**ZONING BOARD OF ADJUSTMENT
P.O. BOX 227
FREEDOM, NH 03836**

Freedom Zoning Board of Adjustment: **October 26, 2021**

Chairman Lees invited Application # **26-4-21 Eugene W. & Denise Lawnicki**. *Continued from September 28, 2021.*

Submittal to the Freedom Zoning Board of Adjustment Regarding Case 26-4-21, Eugene W. and Denise M. Lawnicki, October 26, 2021 meeting

Figure 1 Impact of Proposed House on Hussey View

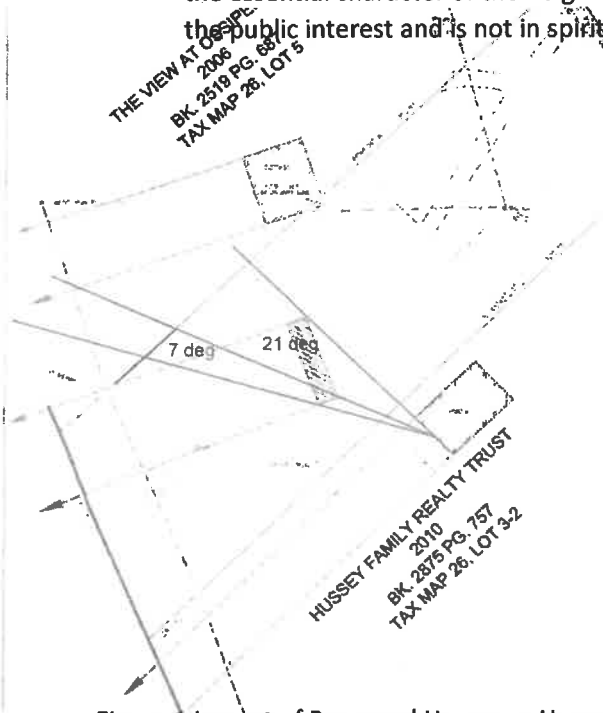
We oppose the Lawnicki's application and ask the Zoning Board to deny the request for variances for two primary reasons. The proposed conditions move the house forward 12.14 feet from the position of the current house. The height of the new structure roof will be approximately 23' (roughly double the height of the existing house), with a higher large chimney on the side of the house facing our house. Moving the structure forward and increasing the height will significantly impact our view to the right and impact the value of our property.

- The approval of the proposal and requested sideline setback would impact our view and property value. Here we are considering the actual viewshed as opposed to the "primary" viewshed presented by the applicant. Since other homes are located about 25' from the bank they have a viewshed from left to right of about 180°. As shown in Figure 1, our current viewshed is less than that due to our desire to address the Lawnicki's concerns in 2003, representing a reduction of 21° degrees on that side. The proposal is to reduce this a further 7° degrees, an additional 30%. The increase in height further decreases our viewshed. It is well known that views affect property value, and obstructions to these views can only negatively affect our property value. This is contrary to statements made in the application relative to Question 4 indicating that the proposed construction will not diminish the values of the surrounding properties.

- The area of the proposed house within the setback is immediately adjacent to our deck. This area of their house is an eating area with a large picture window which will directly overlook our deck. (see Figure 2 as shown in a photo of our deck taken from the location of their window). While the picture shows numerous small trees in this area between the two houses, we expect many of those will be lost during the construction. The placing of this extensive viewing area within the setback is harmful to our privacy and limits the use of our property (and perhaps

- The proposed house is moved 12.14 feet forward from the existing location, and immediately next to the path used by the entire neighborhood, even though the application states that the proposed house will be located “nearly in the same footprint as the existing house and preserves a walking trail between”. Figures 3 and 4 below show the expected change to the appearance of the path with the new structure compared to the existing path. This change alters the essential character of the neighborhood, and as a result, granting the variance is contrary to the public interest and is not in spirit of the ordinance per Questions 1 and 2.

Photo of the current footpath and trees, from east to west, running in front of the Lawnickis' camp, on next page:

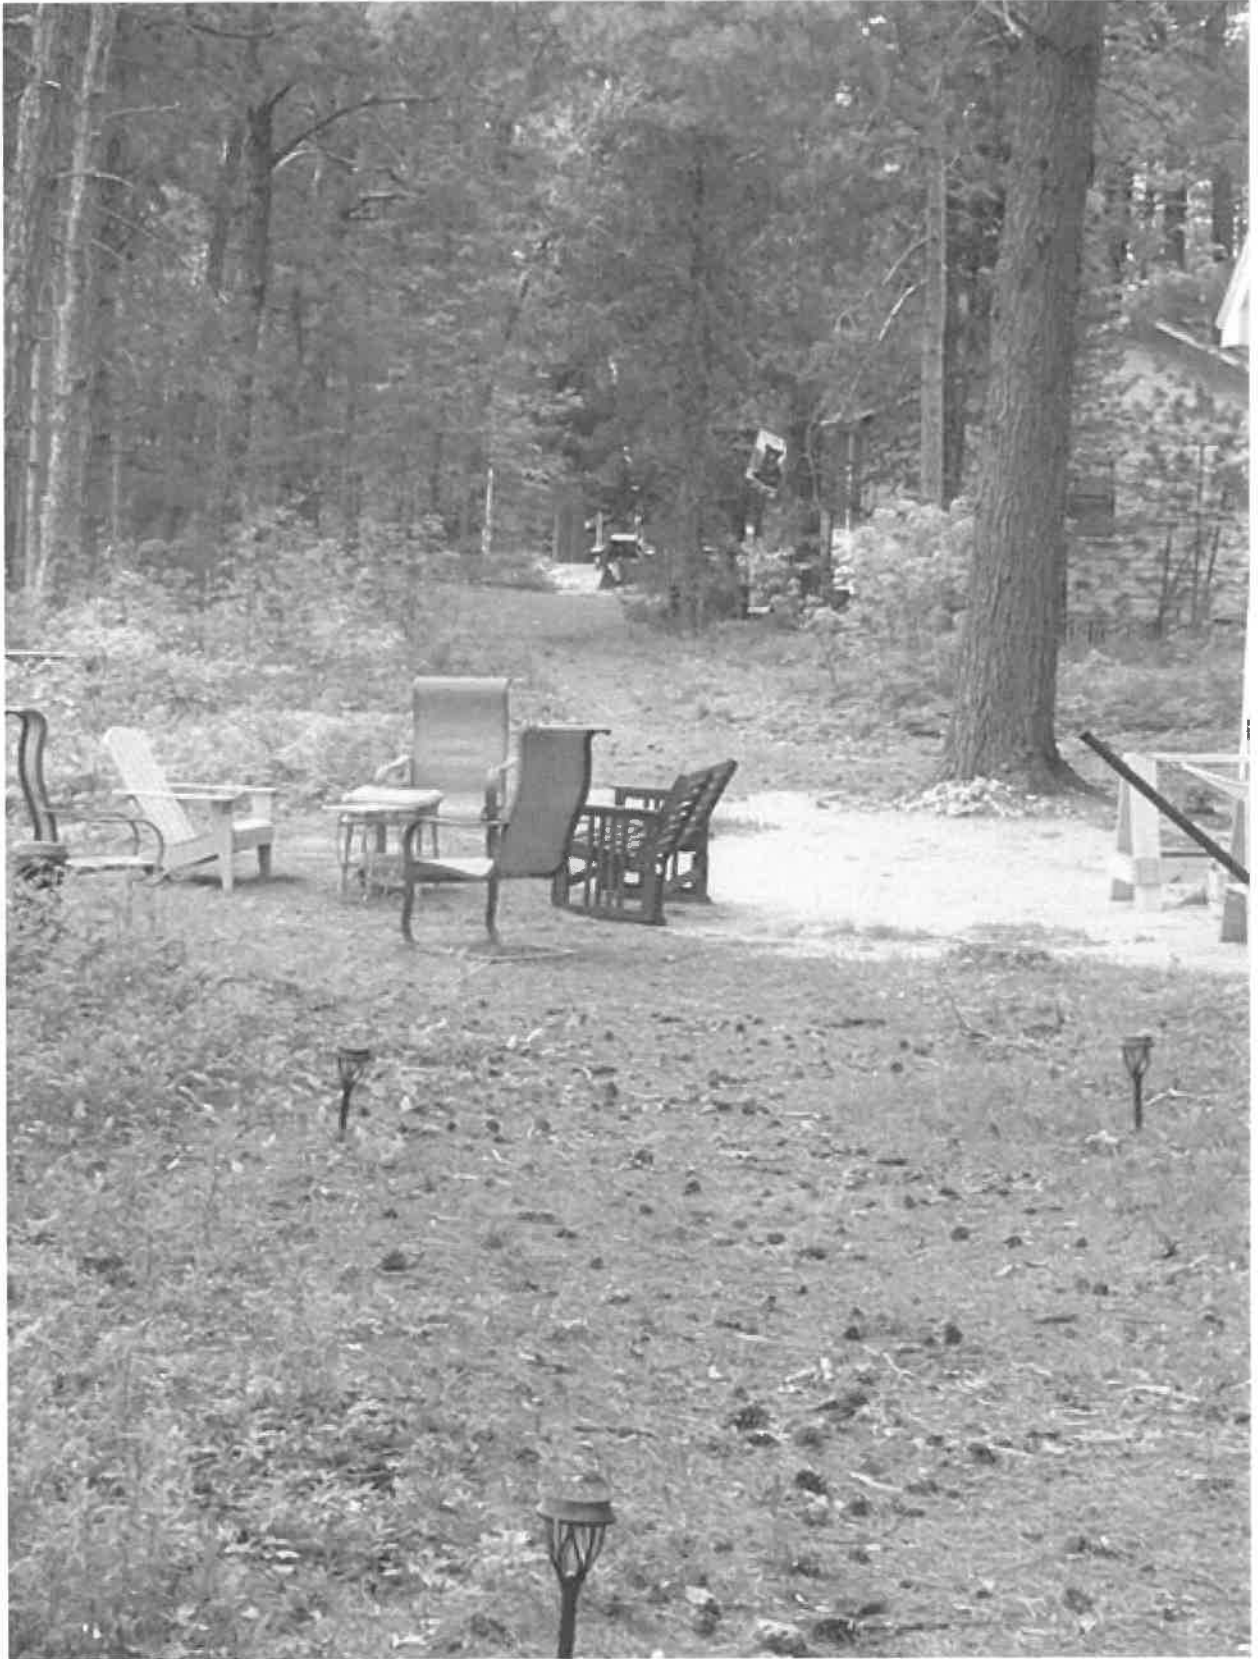
We continue to be both disappointed and exasperated that the Lawnickis have not agreed to move their new structure back to the front line of the current structure. Despite their claims, moving approximately ten feet forward, and replacing a cabin's screen porch with a solid wall at the forward line, as well as constructing a deck at the top of their stairs, will significantly narrow the community footpath and create quite a different sense of openness, altering the essential character of the path. This issue has been raised with the Lawnickis repeatedly since May, but it appears that they have chosen to move forward despite the neighbors' objections. Their proposal will alter the essential character of the neighborhood footpath, which is clearly not in the public interest. The footpath has been in common, continuous use for decades - since the camps were constructed, beginning in 1927 - freely travelled by the camp owners and visitors, including the Lawnickis. The shared path has enhanced the spirit of community along this stretch of Steep Banks. Moreover, moving back approximately 10 feet will protect the essential character of the path, and in no way prevent the Lawnickis from building the home they desire, nor would it be a substantial injustice to them.

Further, despite their claims about "primary viewshed," it is obvious that no one looks down a tunnel, but rather that our camps enjoy a beautiful 180-degree view of the trees on the bank, the lake and distant mountains. The Husseys limited the scope of their own view to accommodate the Lawnickis, and for the Lawnickis to suggest that their new structure will not further interfere with the Husseys' view is disingenuous and misleading.
